PROPOSED SUBDIVISION RESIDENTIAL DEVELOPMENT

201 KEARSARGE WAY

RE: Request for Site Plan Approval at 201 Kearsarge Way, Tax Map 218 / Lot 5

The project received a recommendation for Planning Board approval at the February 7, 2020 Technical Advisory Committee Meeting subject to stipulations. The stipulations, as well as our responses to the stipulations, are listed below:

**SUBDIVISION
SITE PLAN** **C1**

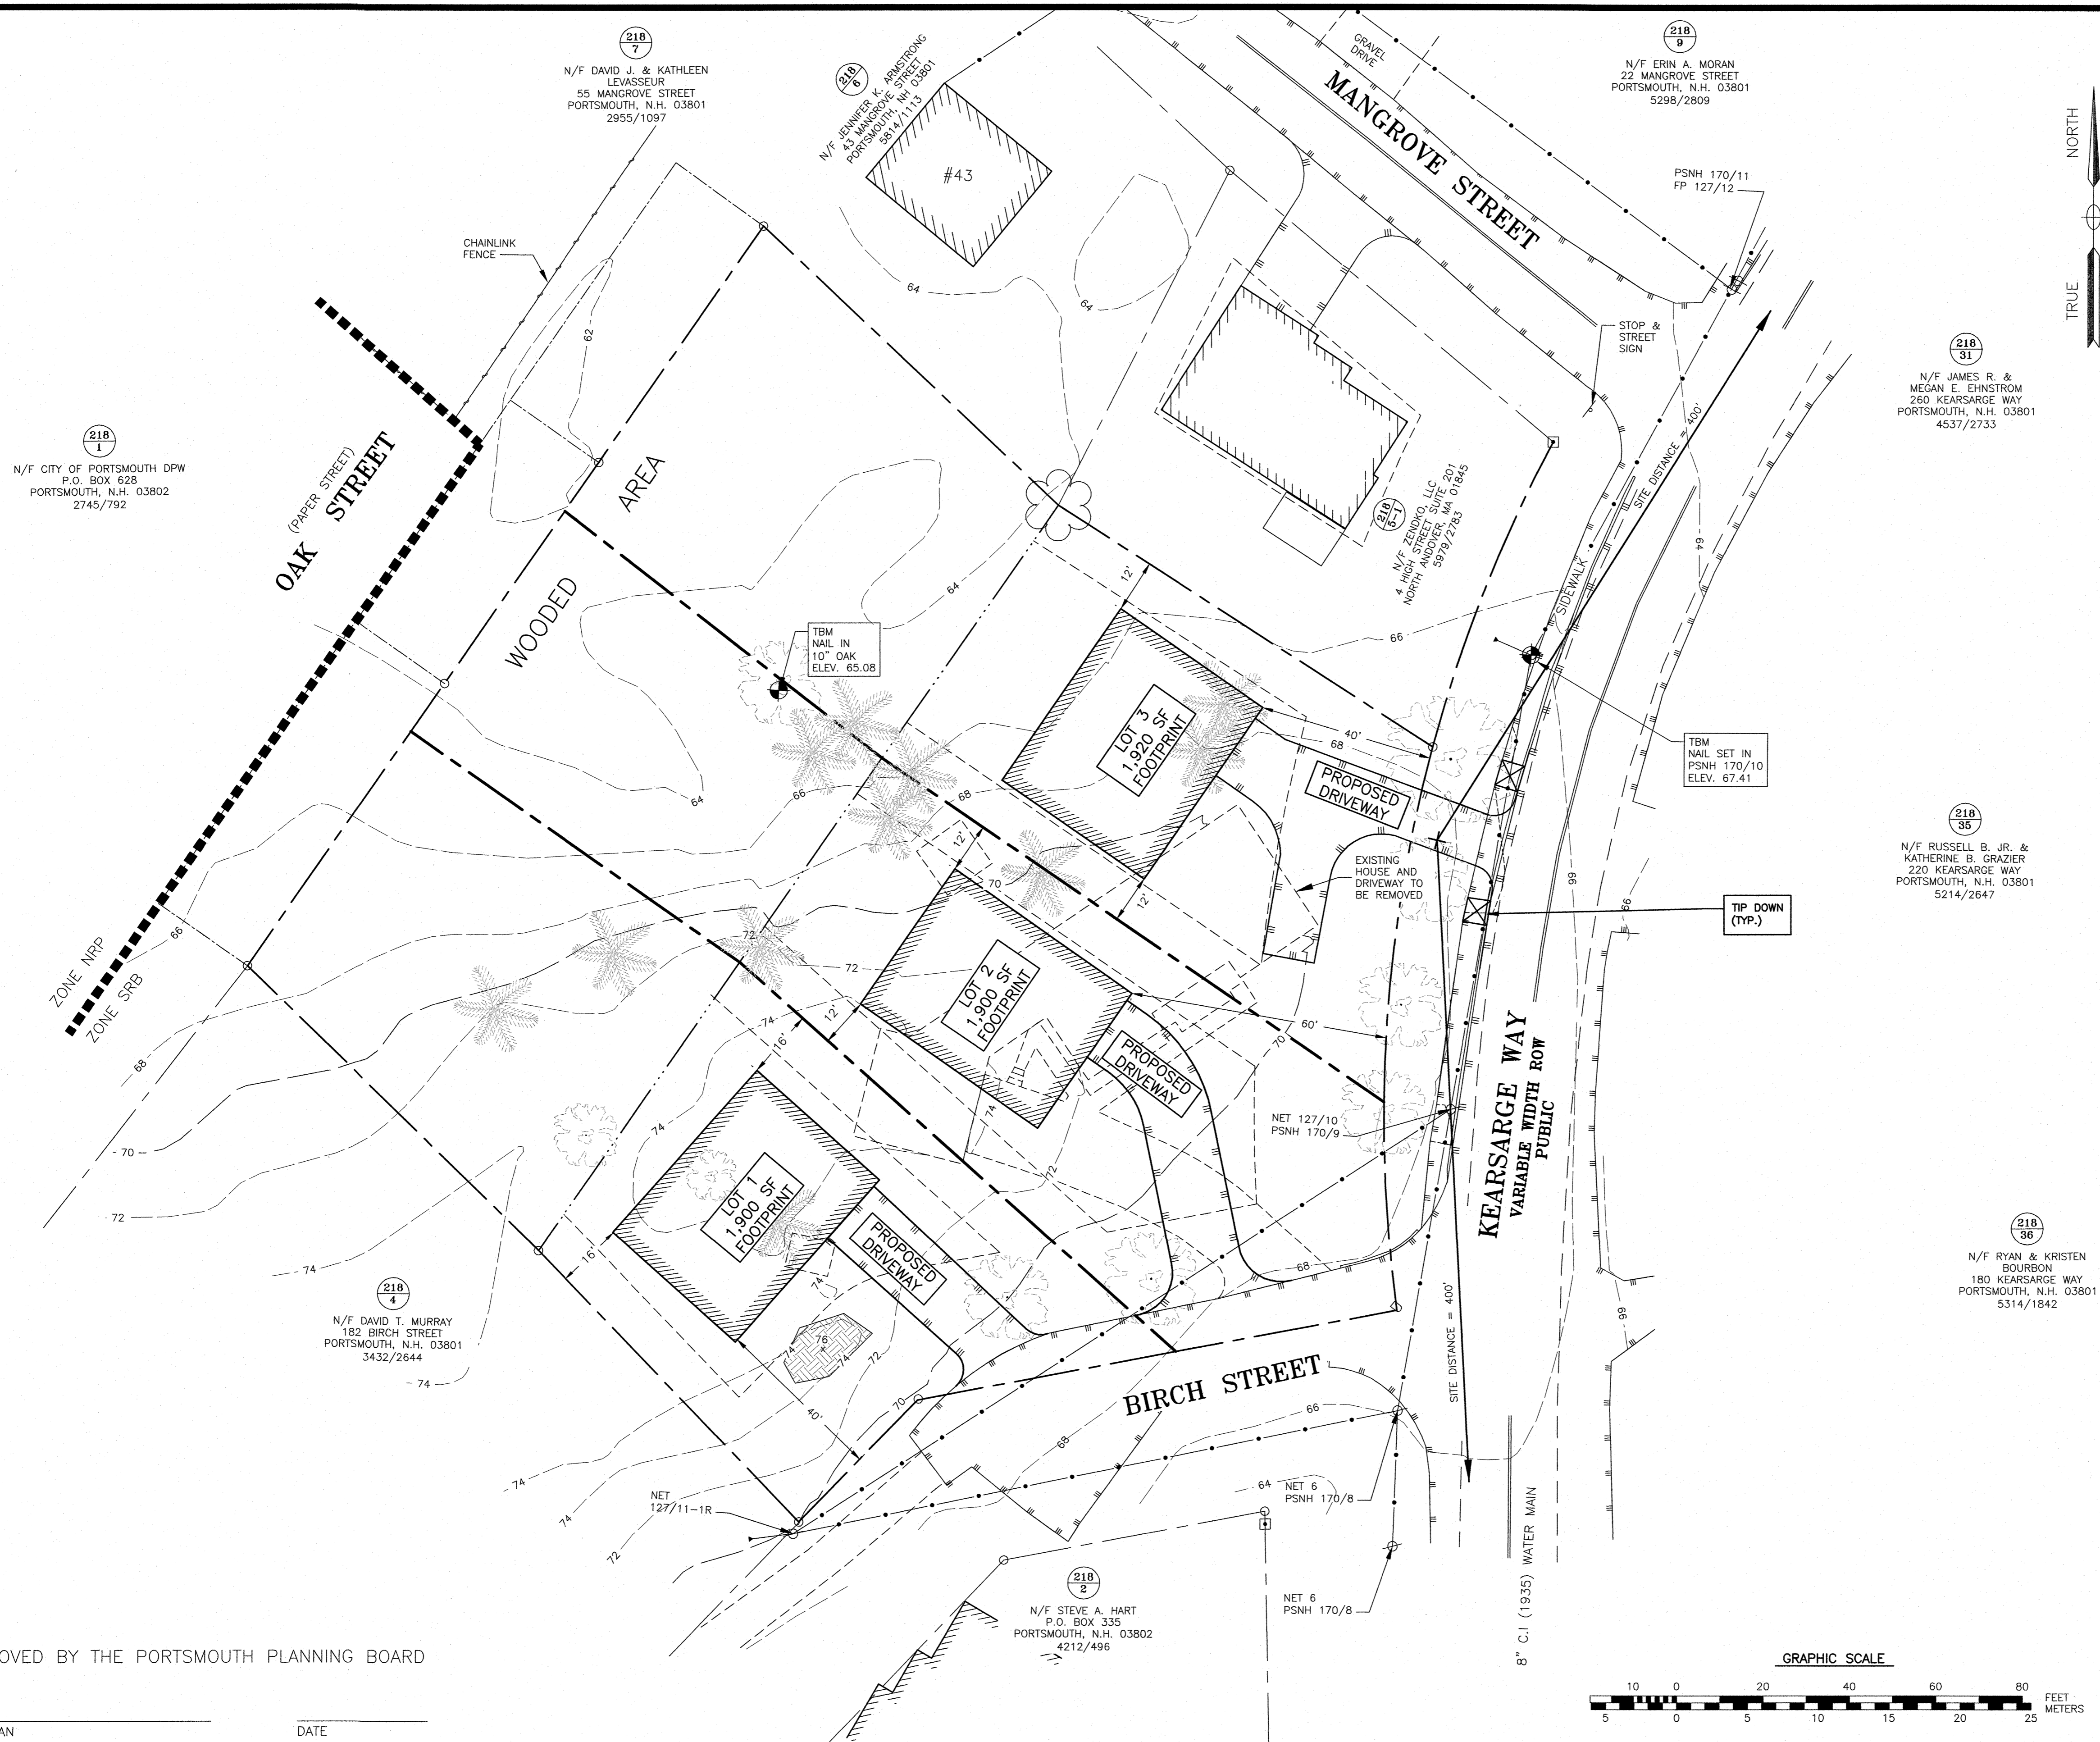
8. Street addresses shall match the driveway locations. **Note 11 has been added to the Subdivision Plan.**
9. Driveway radii on Kearsarge Way shall be tightened. **The driveway radii has been tightened on the plans.**

1. The driveway for Lot 5-4 needs to extend to the street. The sidewalk will need to be modified. This should be shown on the plans. **Plan Sheet C1 has been modified to show the drive extended and tip downs at the drive entrance.**

**GRADING & EROSION
 CONTROL PLAN**

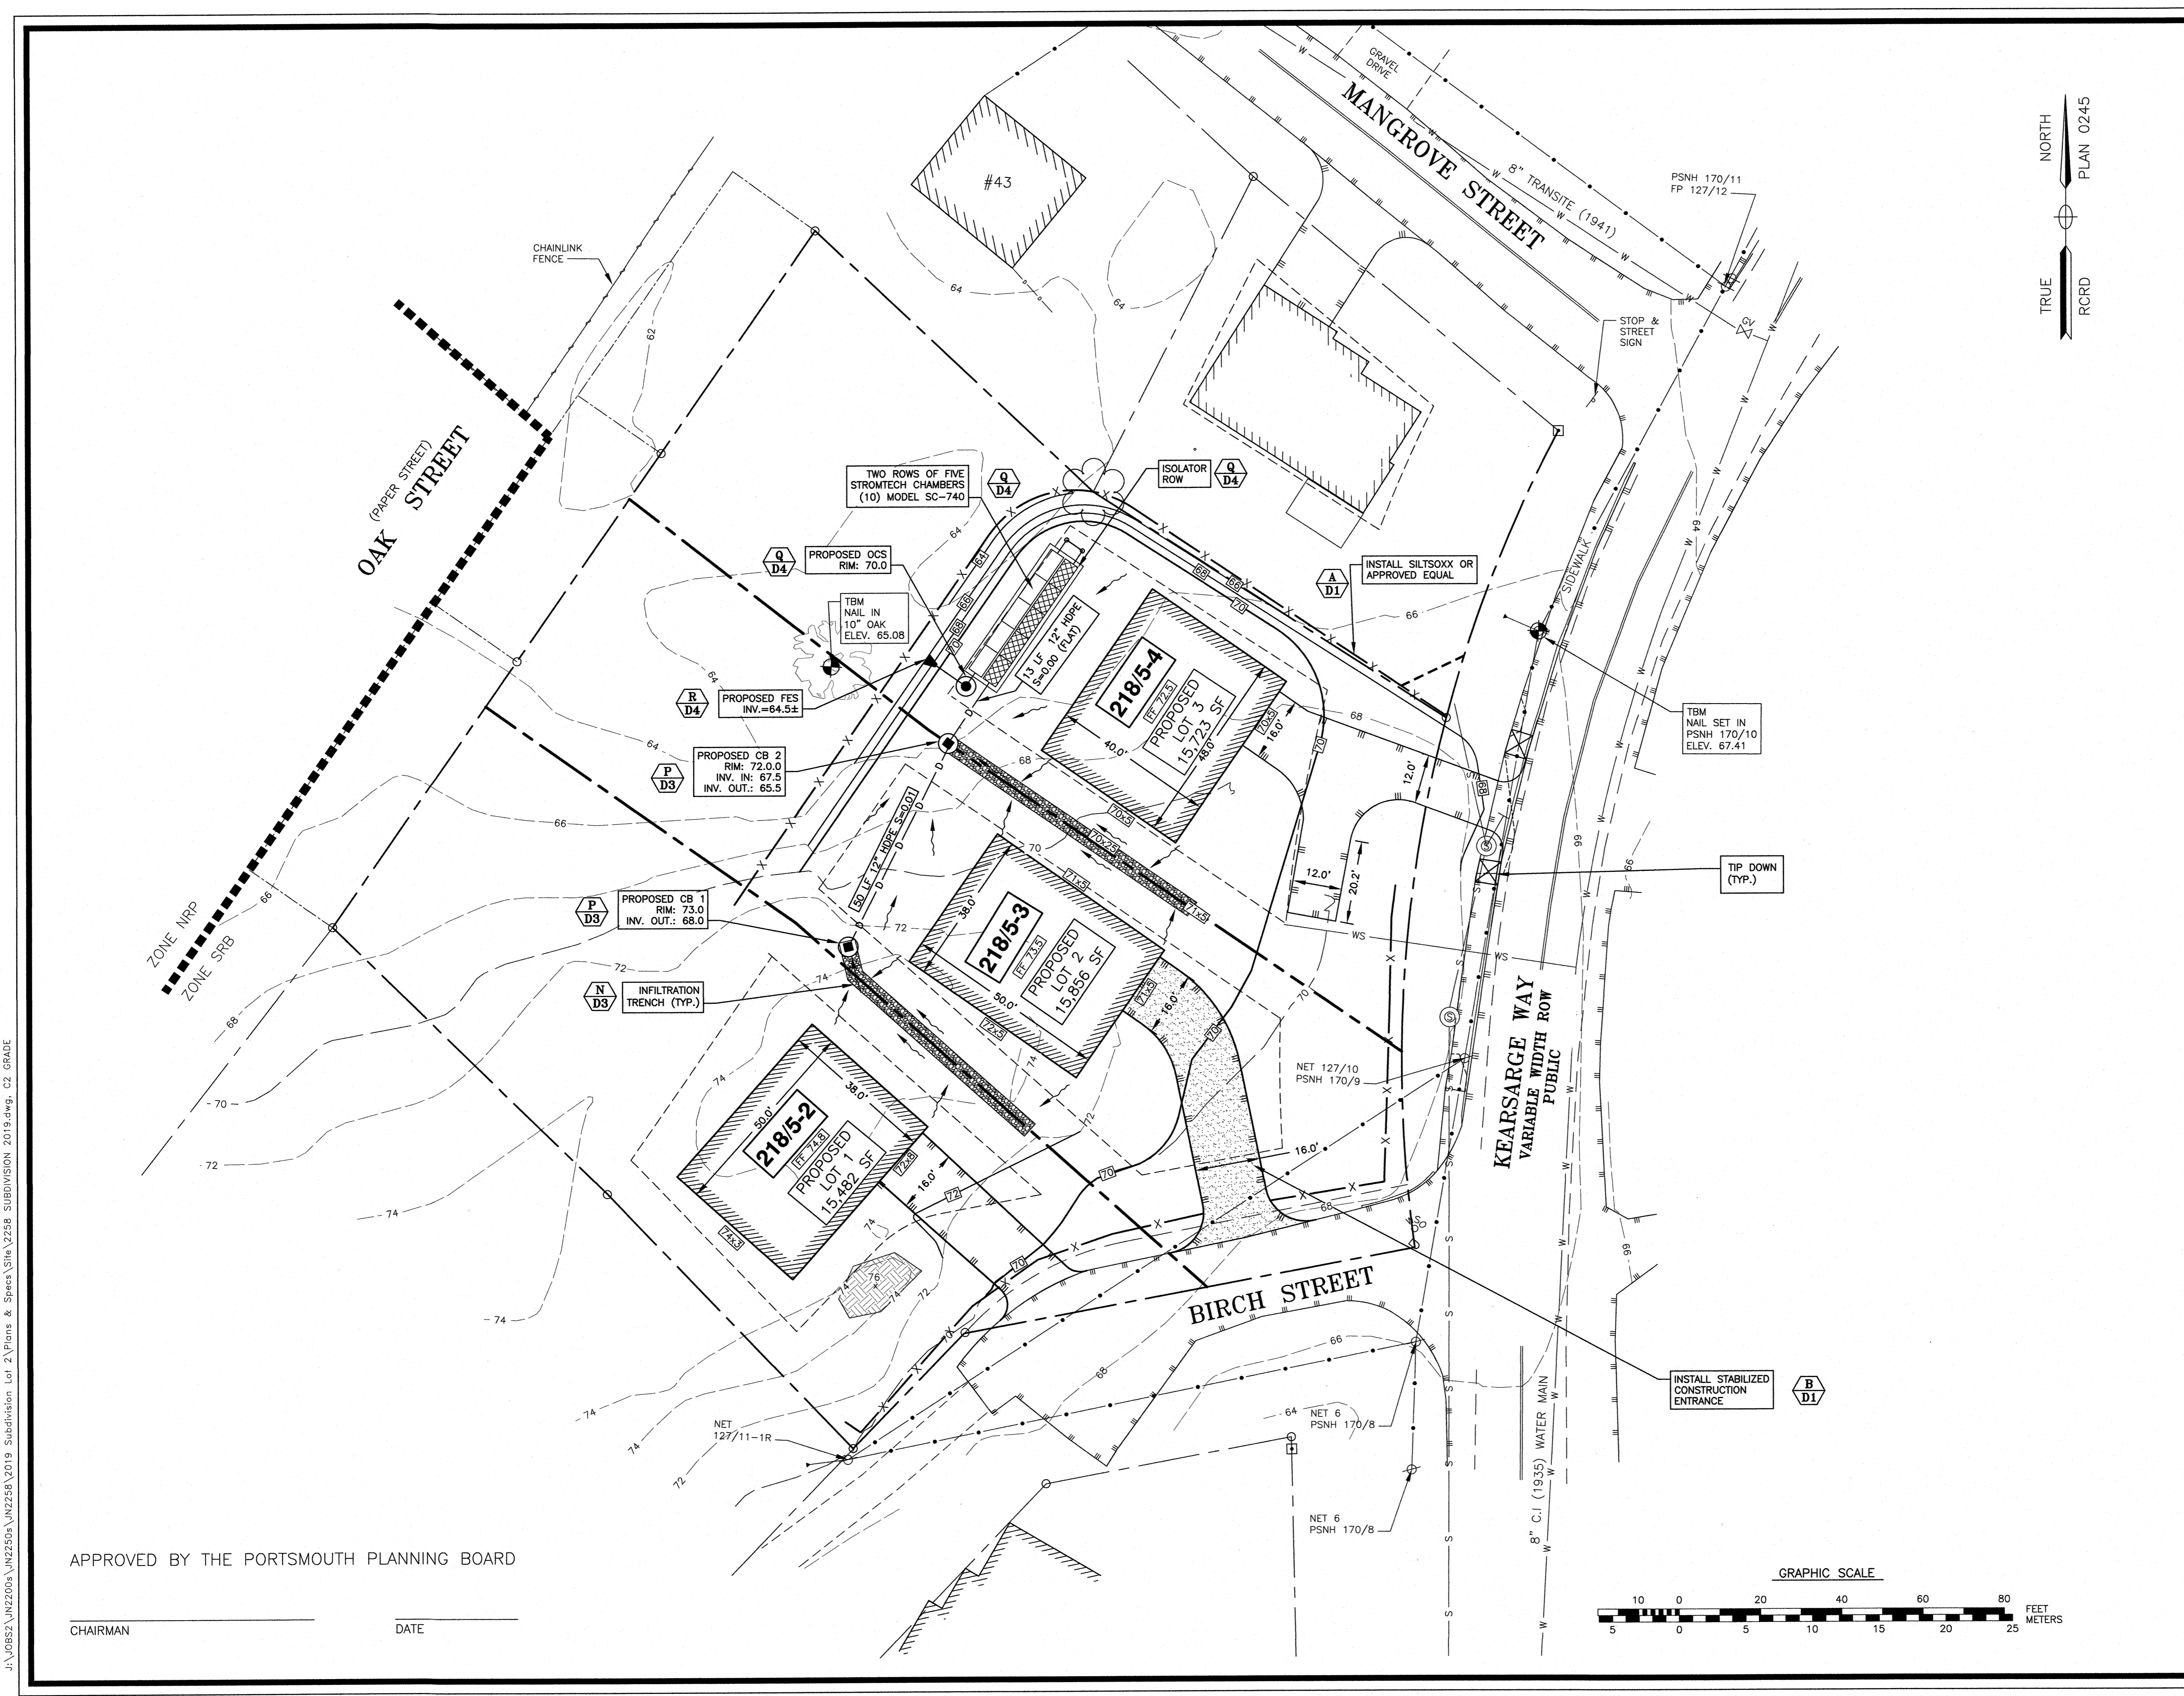
2. The drainage for the houses should be incorporated into the back yard areas where they can be maintained without impacting the portion of the property designated to be a conservation area. **The drainage design has been re-engineered as discussed at the TAC meeting. See Sheet C2, Details P and Q, and the revised Drainage Analysis.**

UTILITY PLAN **C3**

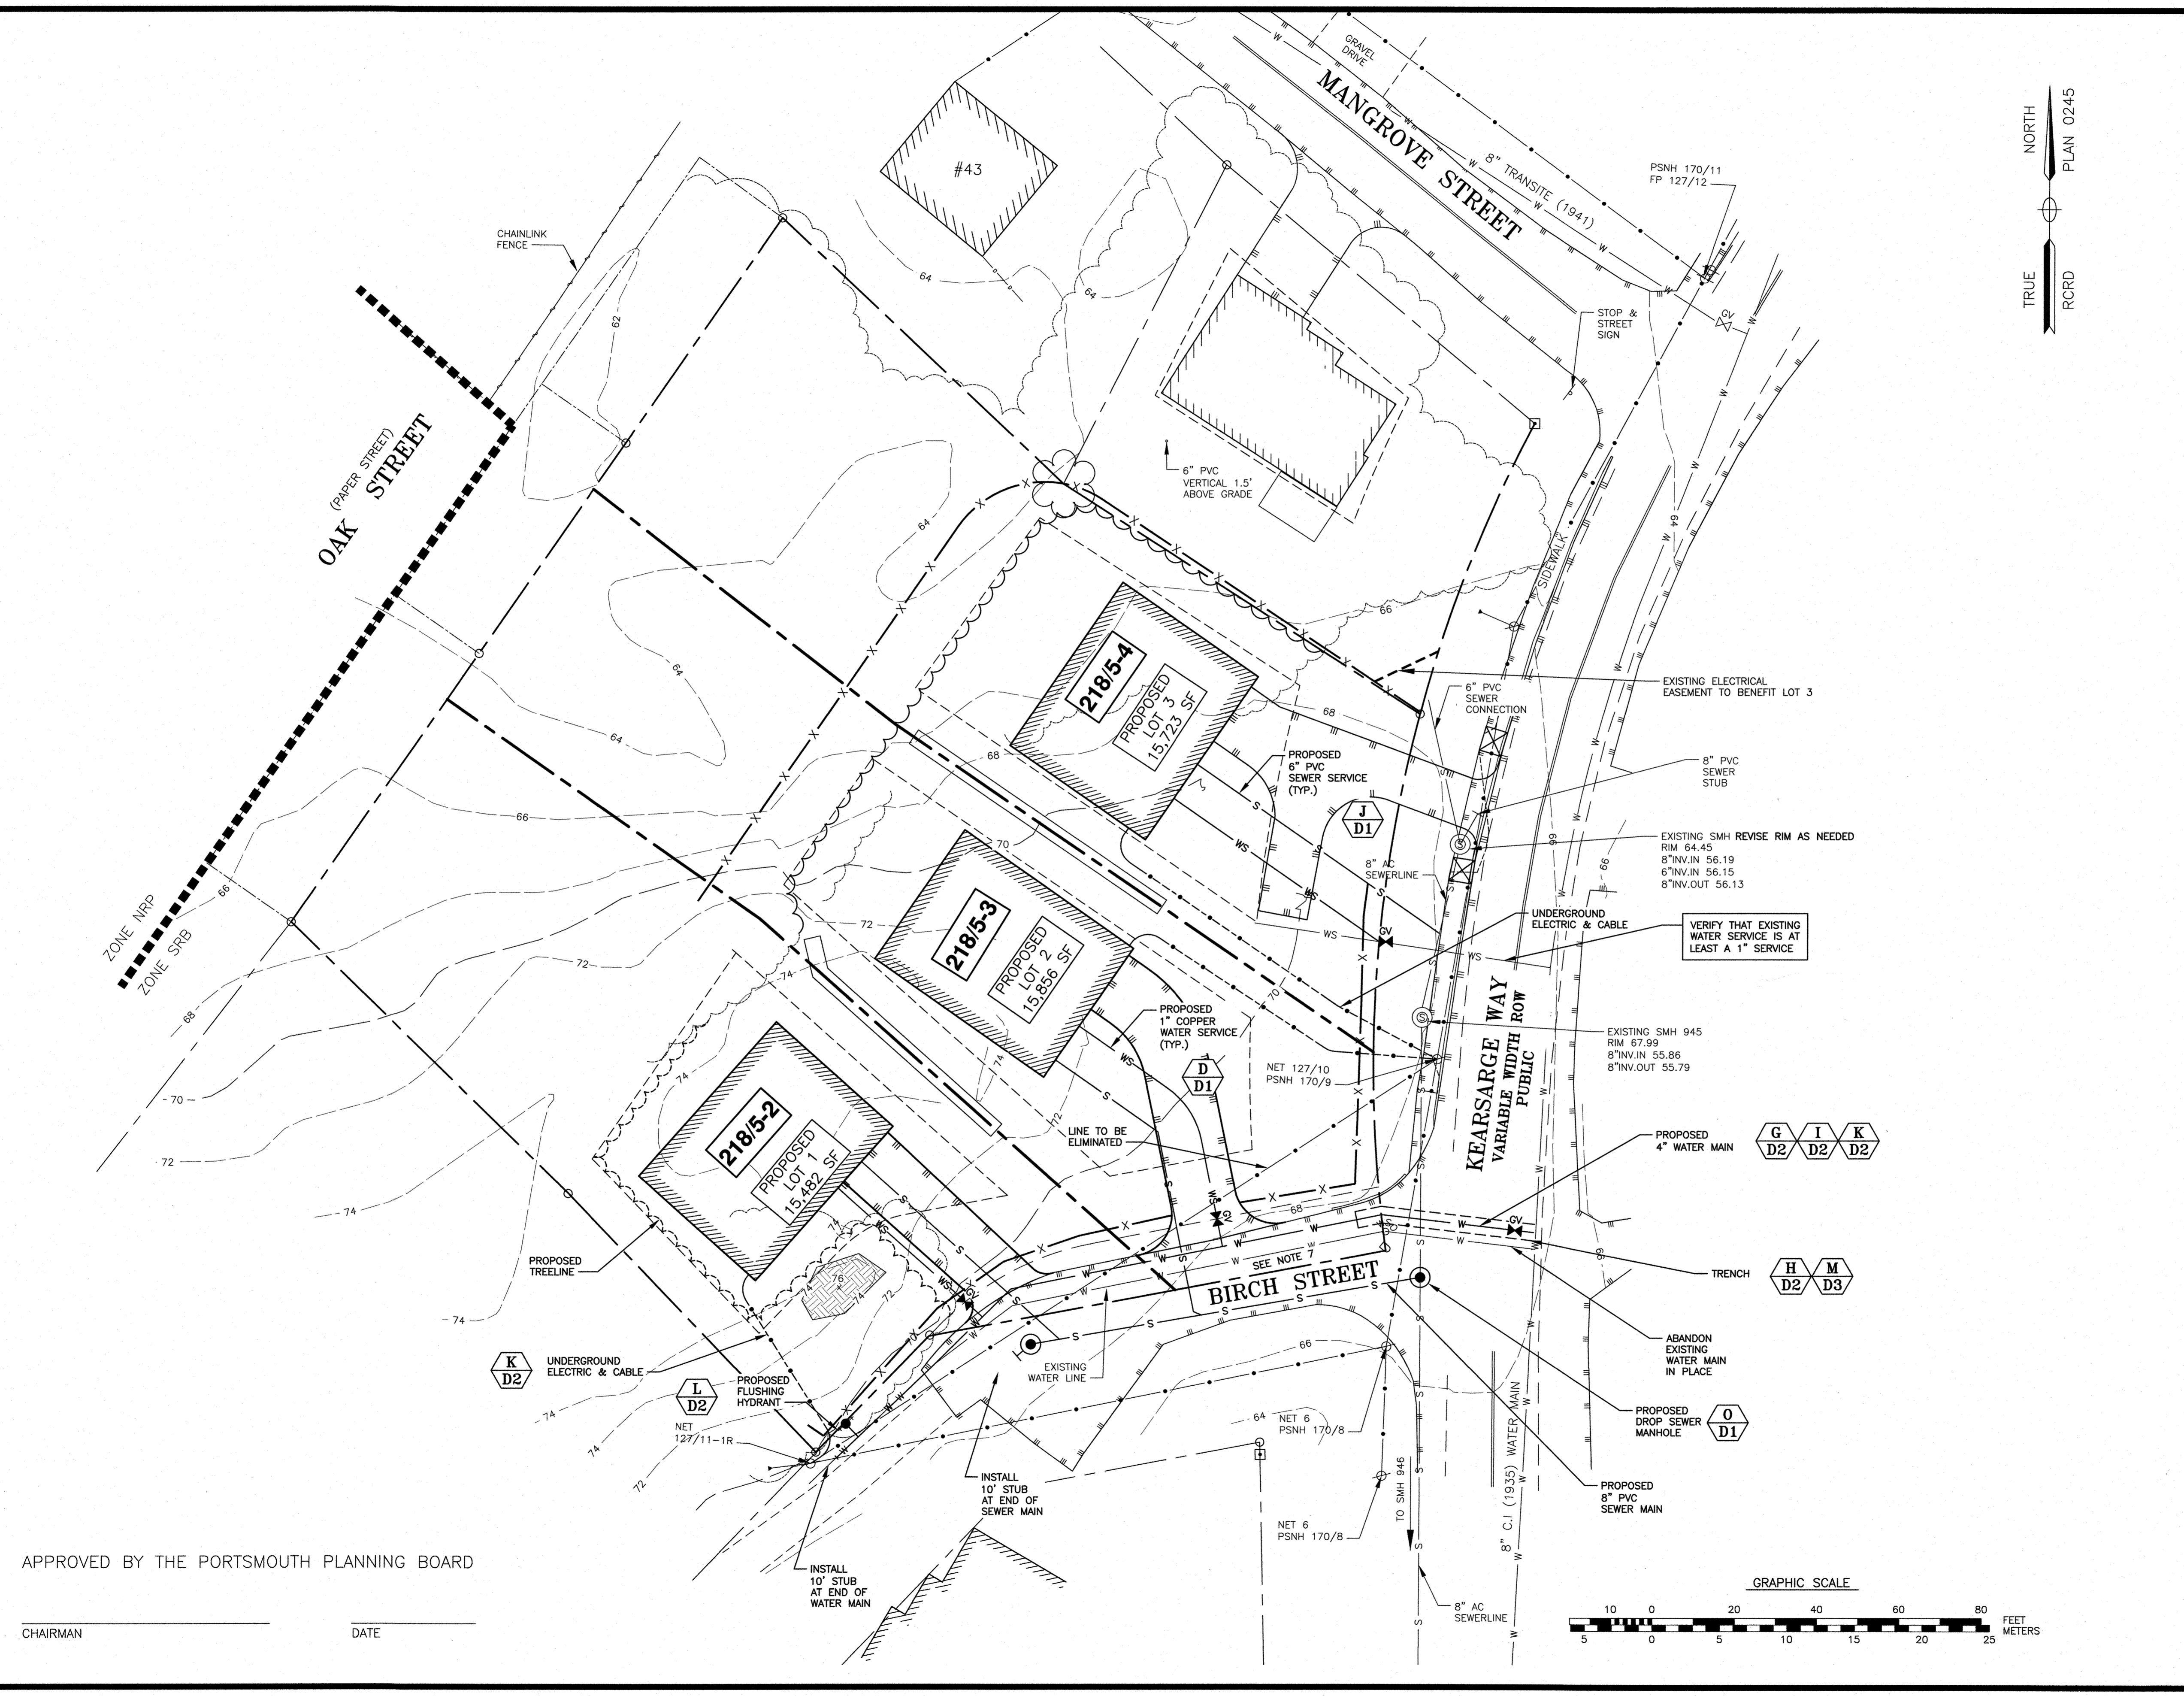
3. Plans shall show 2" water main being abandoned. **The plan has been revised to show the abandonment of the existing 2 inch water main. See Sheet C3 and P1.**

6. Add location of gas, electric, and communication lines to plan. **The electric and communication lines and services have been added to Sheet C3. Currently there are no gas lines along Kearsarge Way in this vicinity.**
